STAFF RECOMMENDATION 1515 Beechwood Avenue November 15, 2017

Application: New construction—outbuilding/detached accessory dwelling unit

Description of Project: Application is to convert an existing outbuilding into a detached accessory dwelling unit (DADU).

Recommendation Summary: Staff recommends disapproval of the detached accessory dwelling unit, finding that the height, eave height, and roof of the outbuilding will not meet Section 17.16.030.G of the Metro Code or Section II.B.1.i of the Belmont-Hillsboro Neighborhood Conservation Zoning Overlay Design Guidelines.

Figure 1. Existing outbuilding

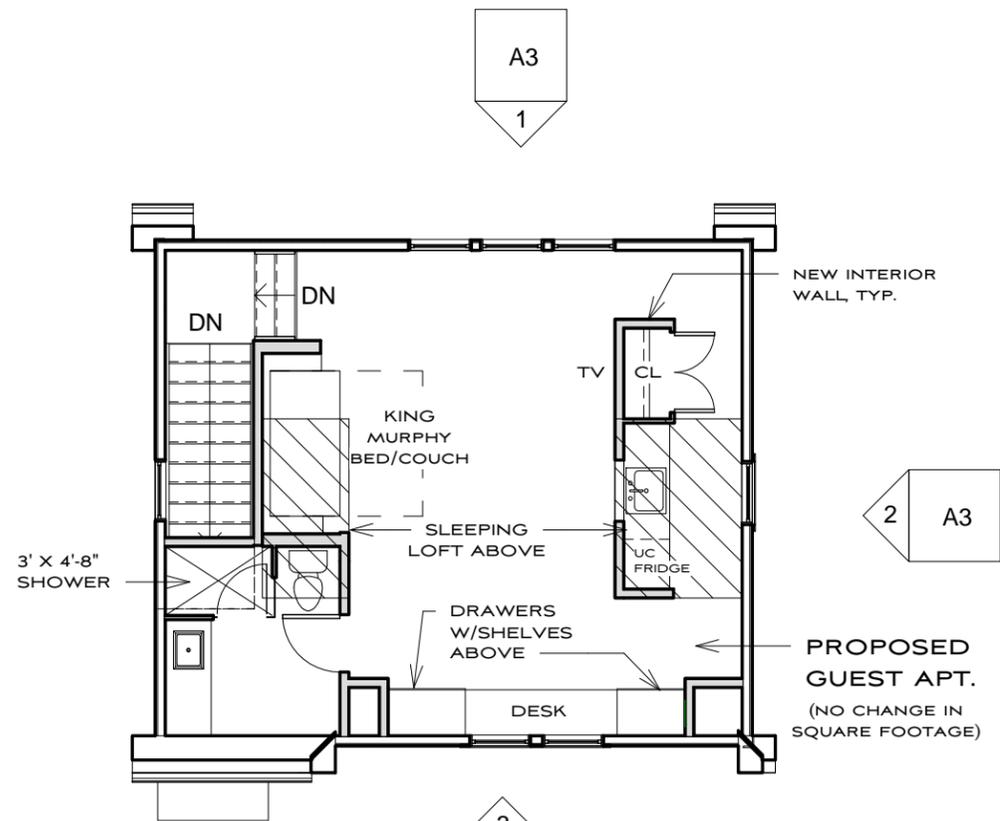
Materials and Partial Demolition: The only change proposed to the existing outbuilding is a new door on the east façade. With Staff approval of the new door, this alteration would meet Section II.B.1.i for Windows & Doors.

At the time the outbuilding was first reviewed, the Commission followed different design requirements for DADUs than for garages. DADUs, established in 2011, were required to be no more than twenty-five feet (25') tall and dormers were not allowed to cover more than 50% of the roof plane; however, in this case, the request in 2012 was for a garage

without dwelling space. The 2012 plans call out the outbuilding as a “garage and studio.” Floor plans do not show evidence of a dwelling unit as they do not include a kitchen or a full-bath. The twenty-eight feet (28’) of height and full-width wall dormer were therefore approved as the new principal dwelling was thirty-two feet (32’) tall and there was no request for dwelling space.

Although the overall height is subordinate to the principal structure the ridge and eave heights are beyond the maximum heights allowed by Code. Staff finds that the outbuilding does not meet Section II.B.1.i of the district design guidelines, nor Section 17.30.060.G for DADUs.

The rear roof features a wall dormer spanning the entire width of the structure. Section II.B.1.i of the design guidelines, and Section 17.16.030.G.8 of Code require that dormers shall be subordinate to the building's roof by covering no more than fifty percent (50%) of the roof and that dormers should step-back from the roof below by at least two feet (2'). The combination of high eave height with large wall dormer results in a building that is more of a two-story form rather than a one and one-half story form, which would be more appropriate with this one- and one-half story principal dwelling. Staff finds that the existing outbuilding will not meet these sections of the guidelines and Code.

MARTIN GARAGE
1515 BEECHWOOD AVE
PROPOSED PLAN
10-31-17

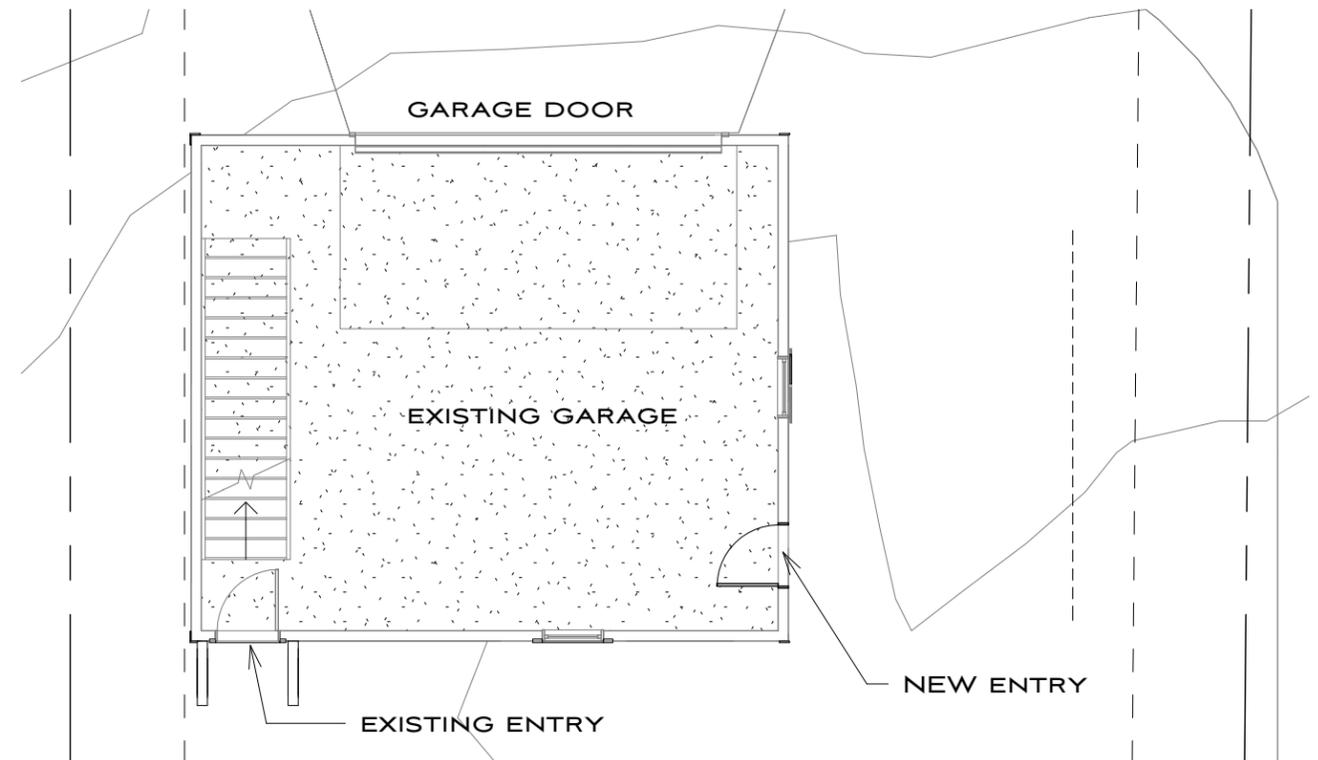
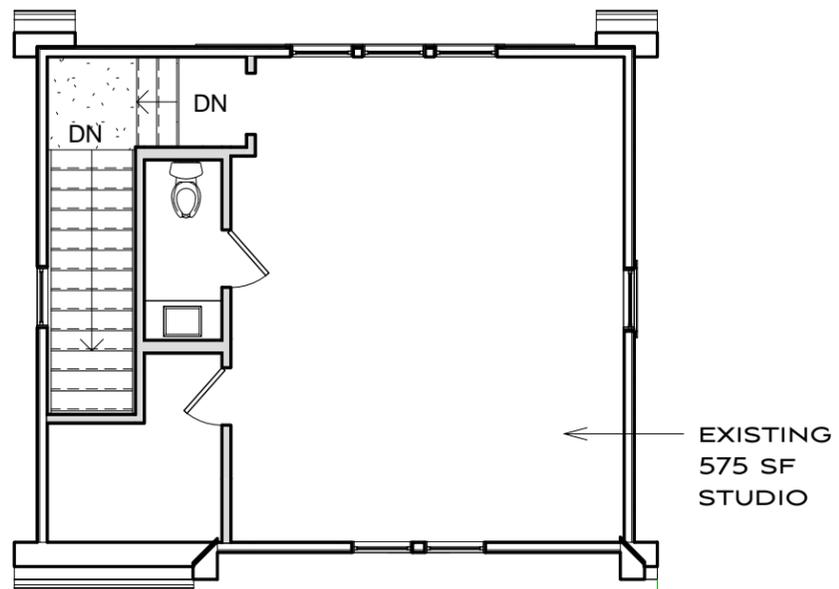
YES	NO
Does the lot NOT comply with Table 17.12.020A of the zoning code? (It isn't zoned two-family or doesn't have adequate square footage to be a legally conforming lot.)		No
Are there other accessory buildings on the lot that exceed 200 square feet?		No
Is the property zoned single-family?		No
Are there already two units on the property?		No
Does the property owner NOT live on site or does NOT plan to move to this location once the DADU is complete?		No
Is the planned conditioned living space more than 700 square feet?		No
Are the stairs unenclosed?		No
